# 42 HONEYSUCKLE DRIVE COTTAGE CREEK PRECINCT NEWCASTLE

STATE SIGNIFICANT DEVELOPMENT (SSD-10378)  
DEVELOPMENT MODIFICATION 2

ARCHITECTURAL DESIGN STATEMENT

NOVEMBER 2021

# 3.1 DESIGN CHANGES THIRD FLOOR PARKING

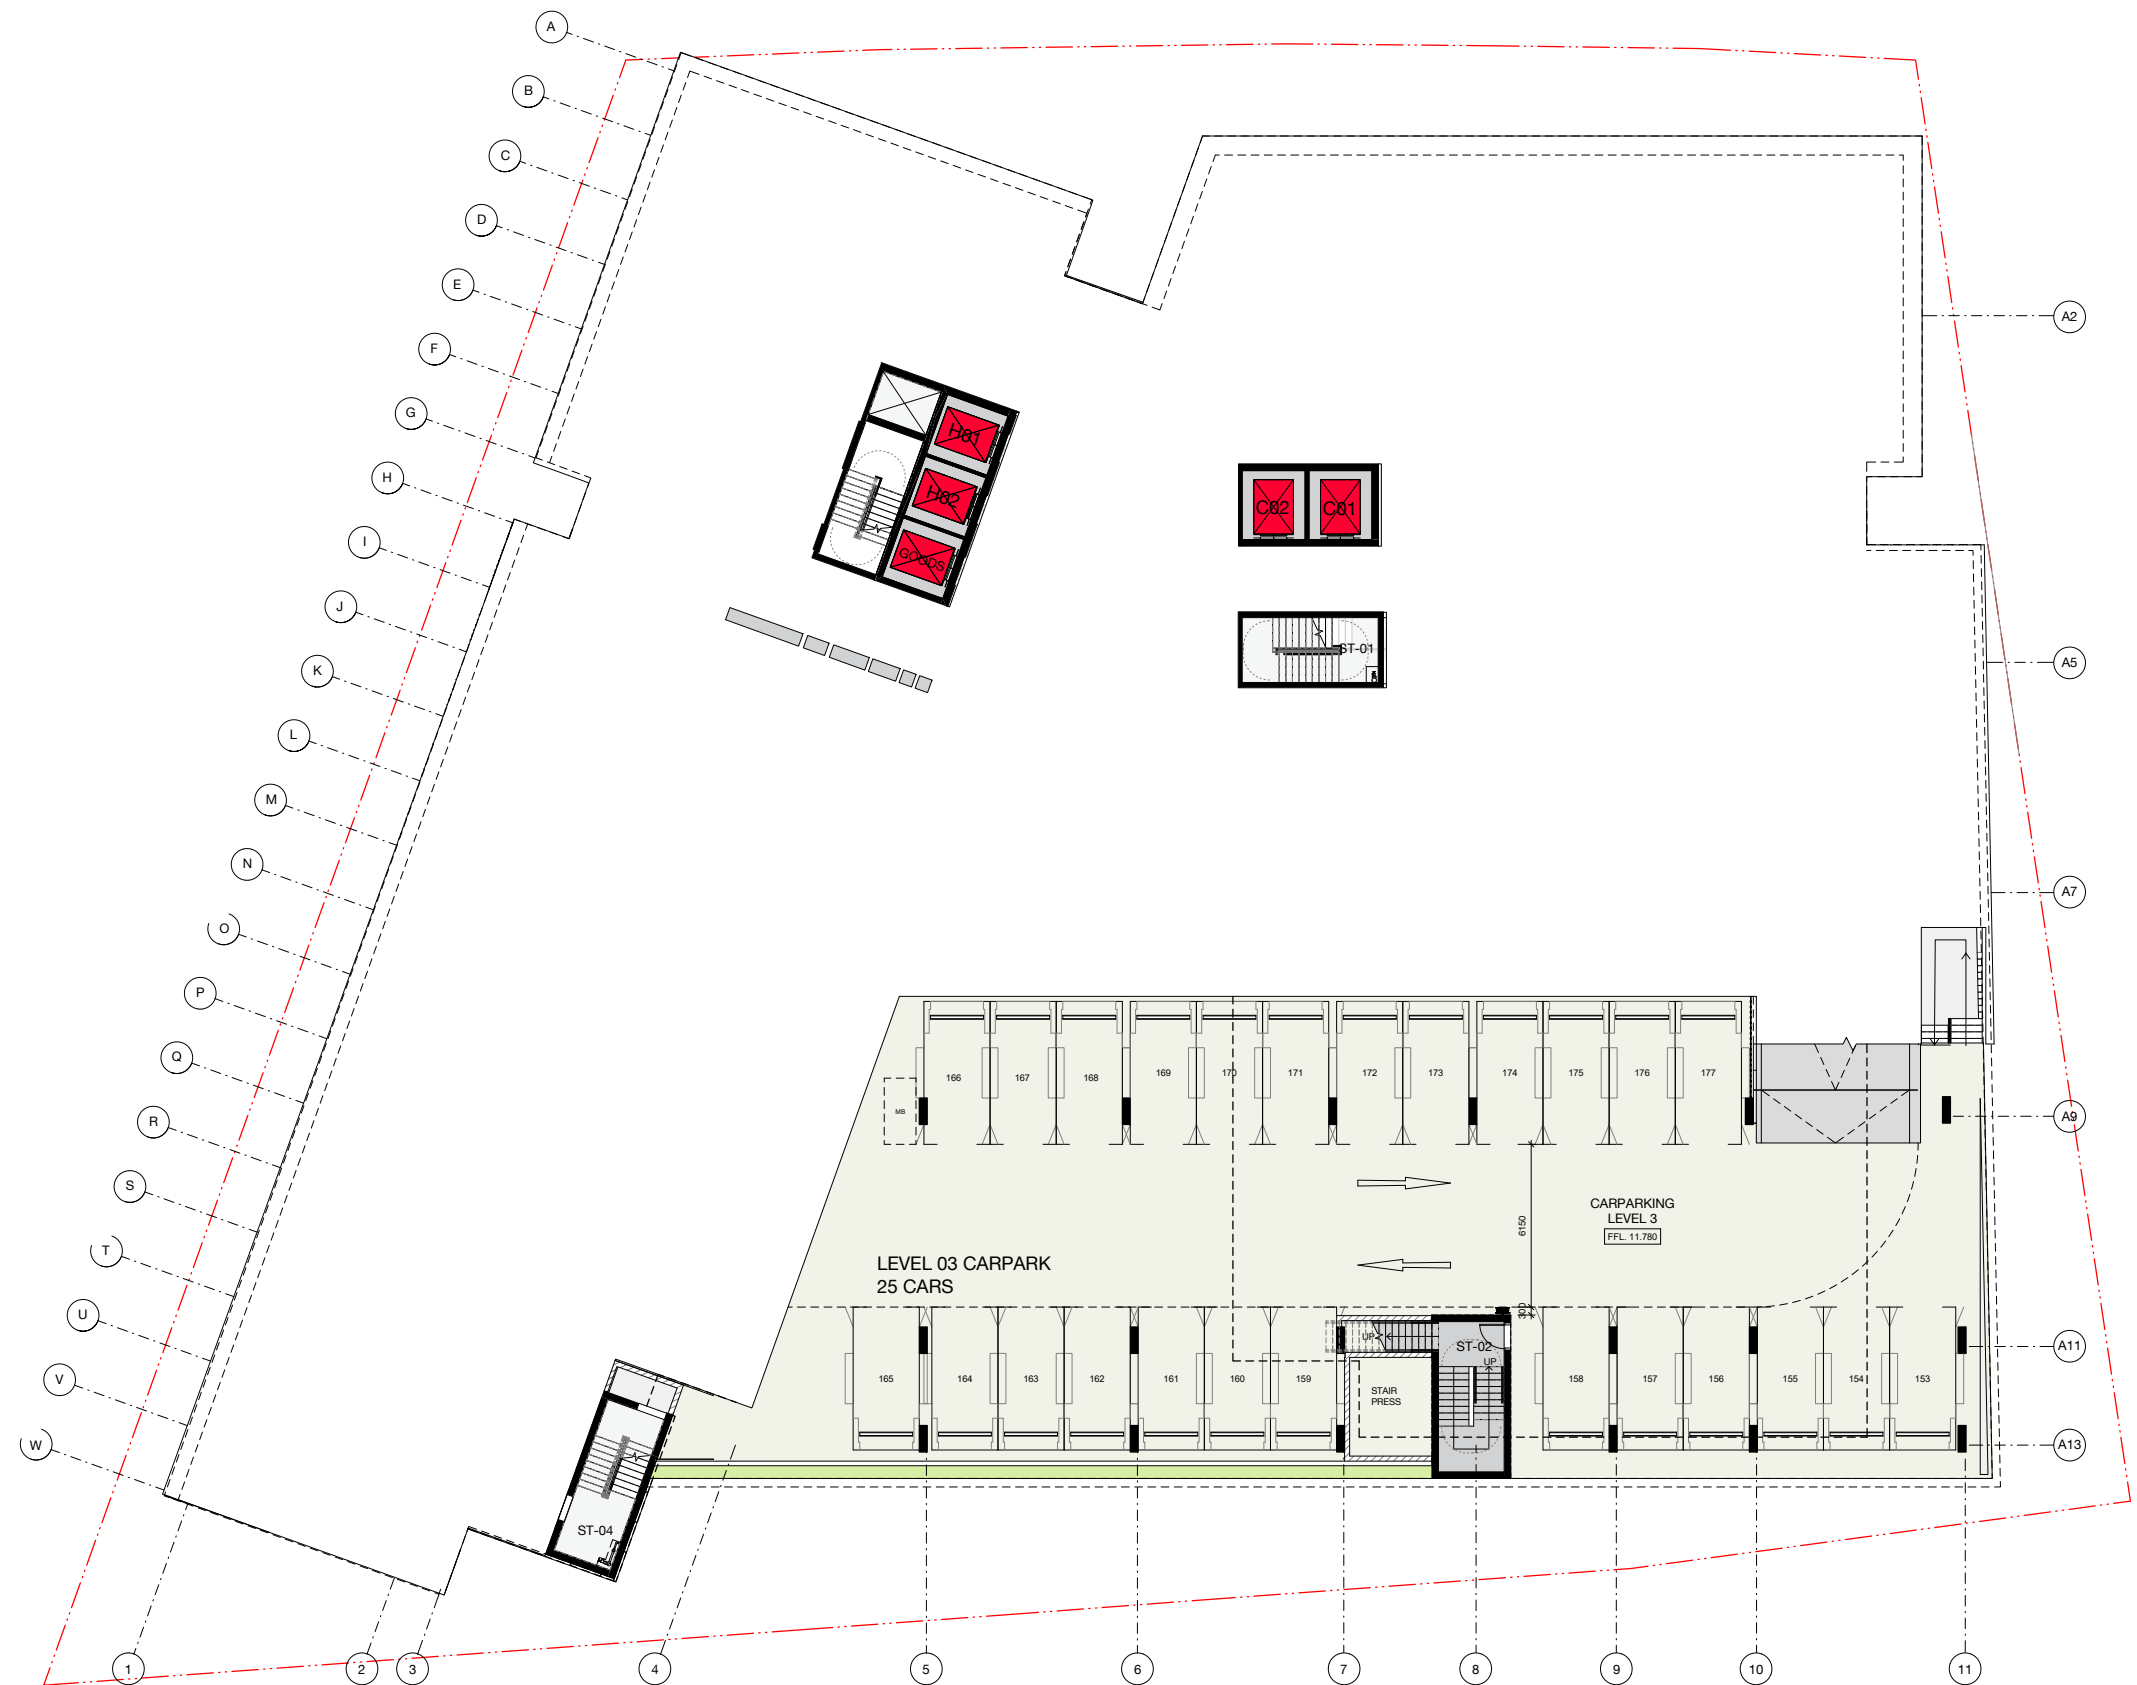
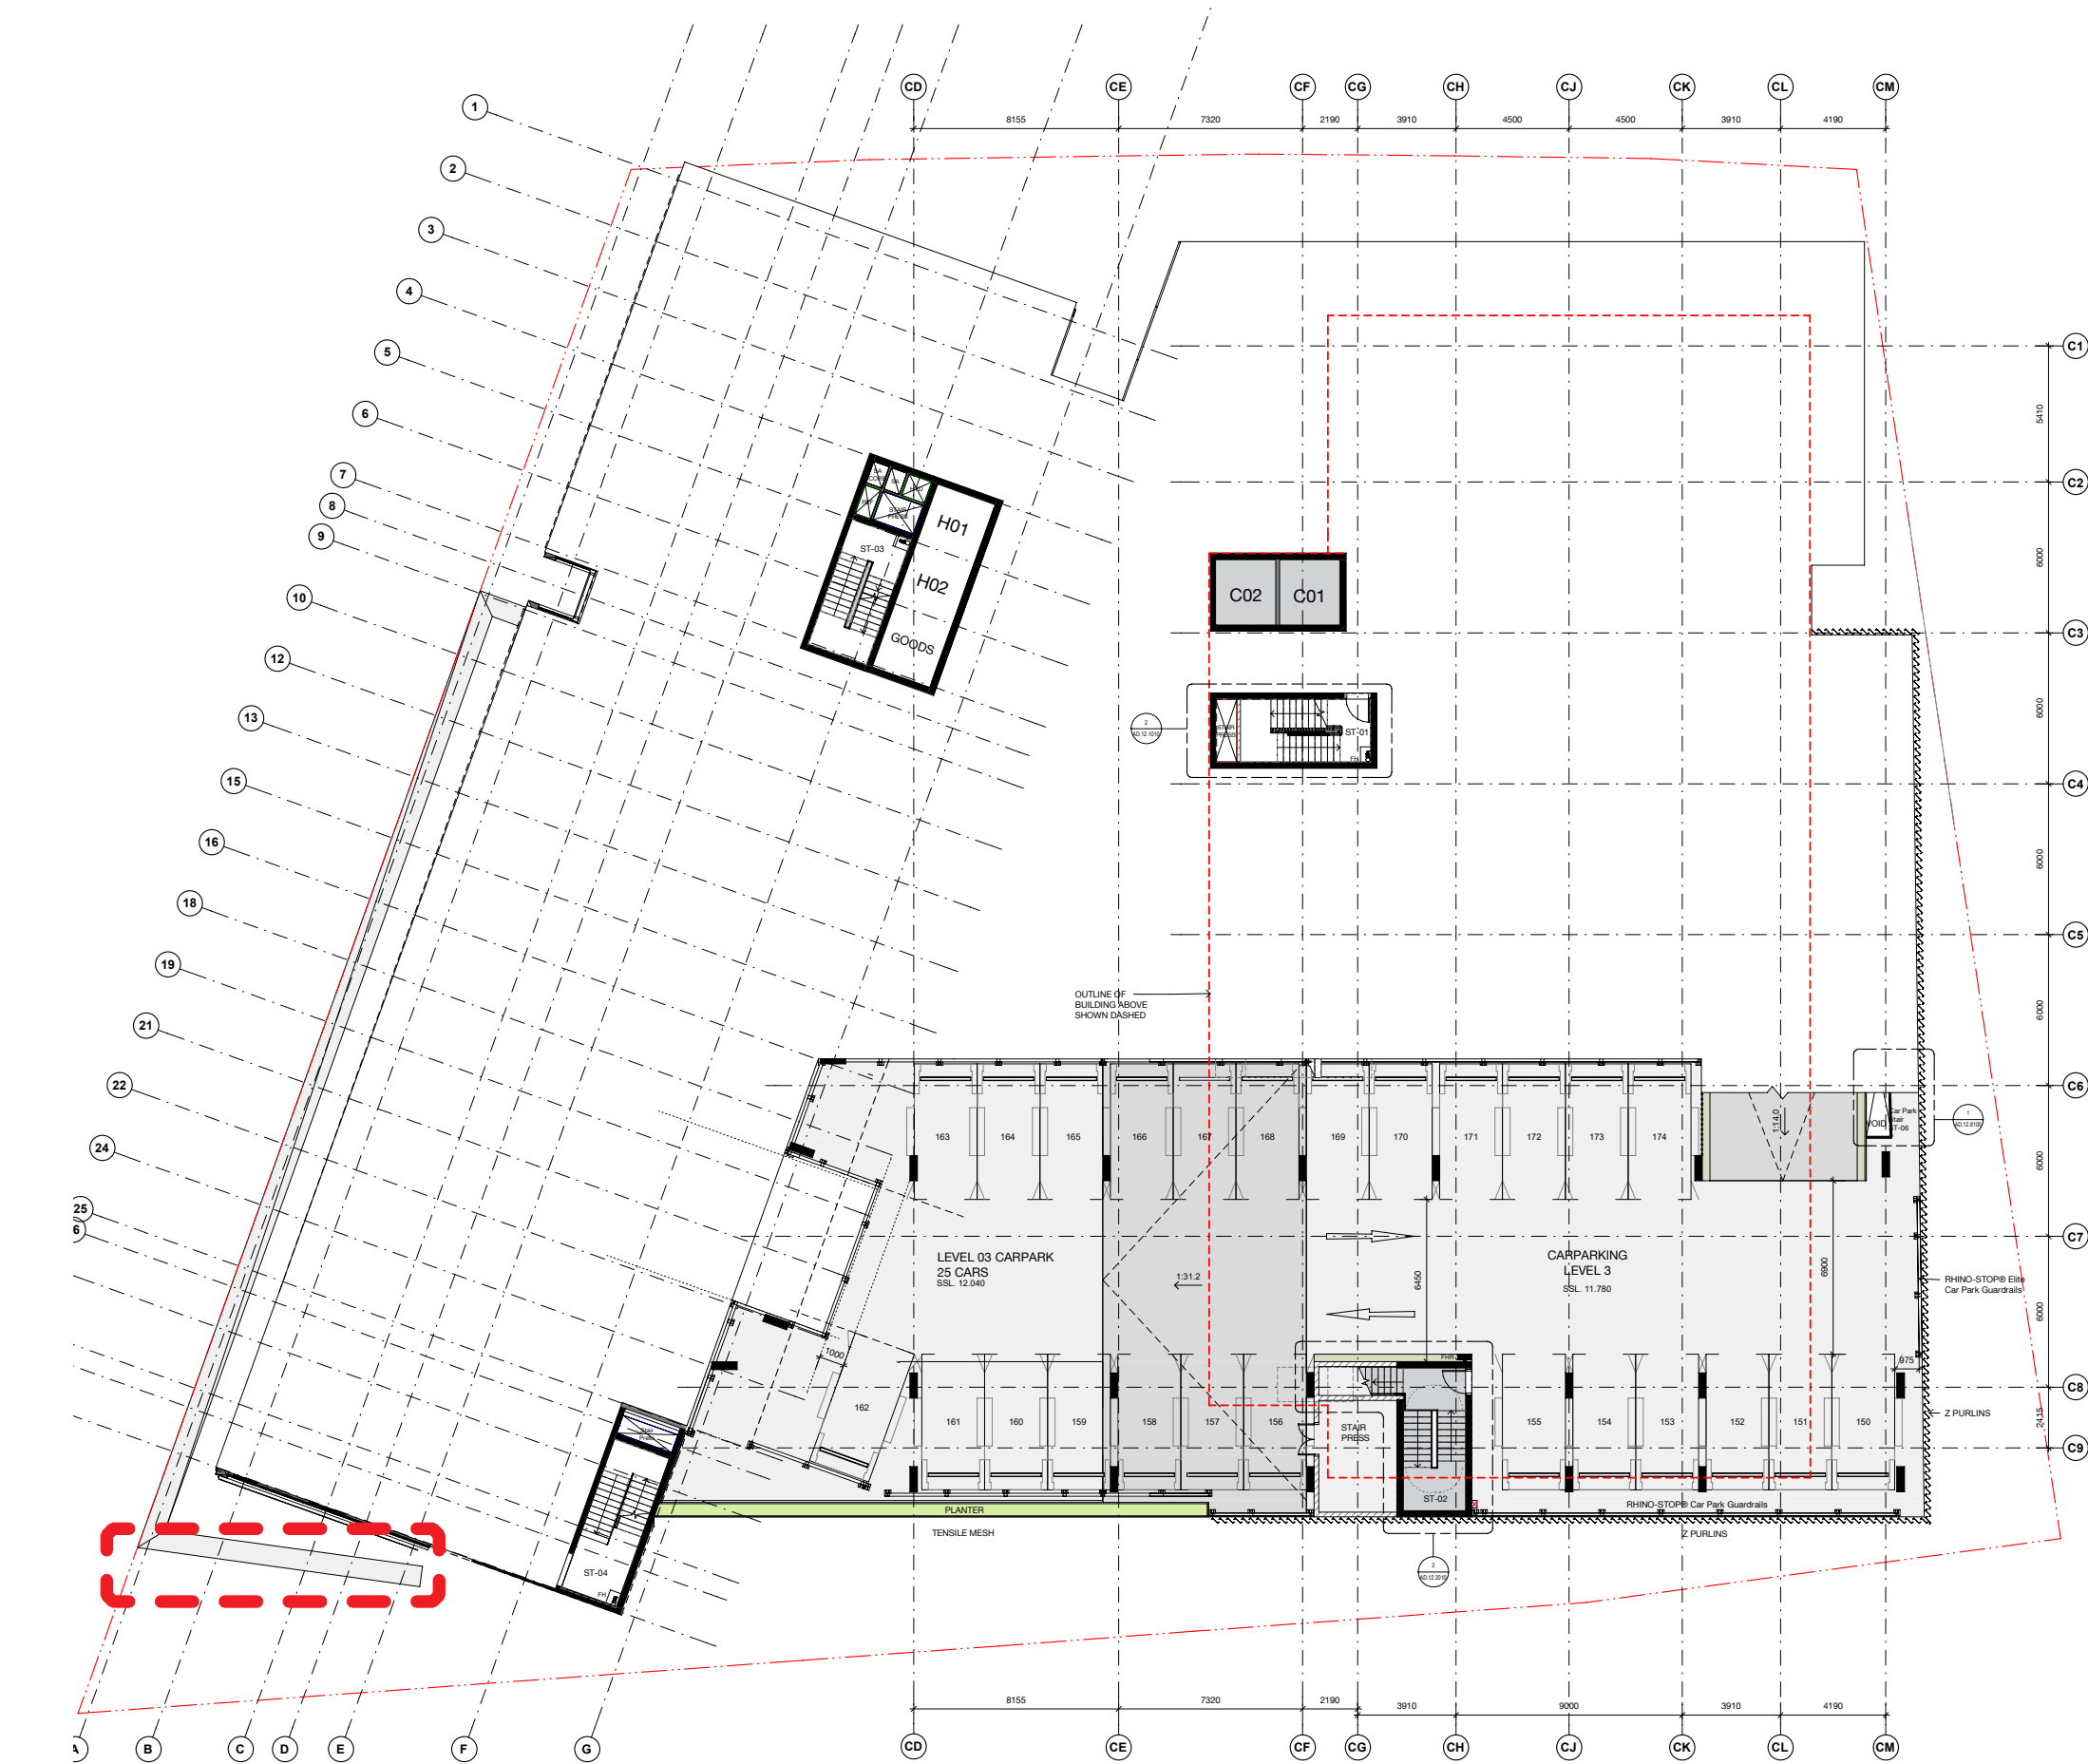
1 / South west end of the building at levels L00/L01/L02 set back from south boundary line.
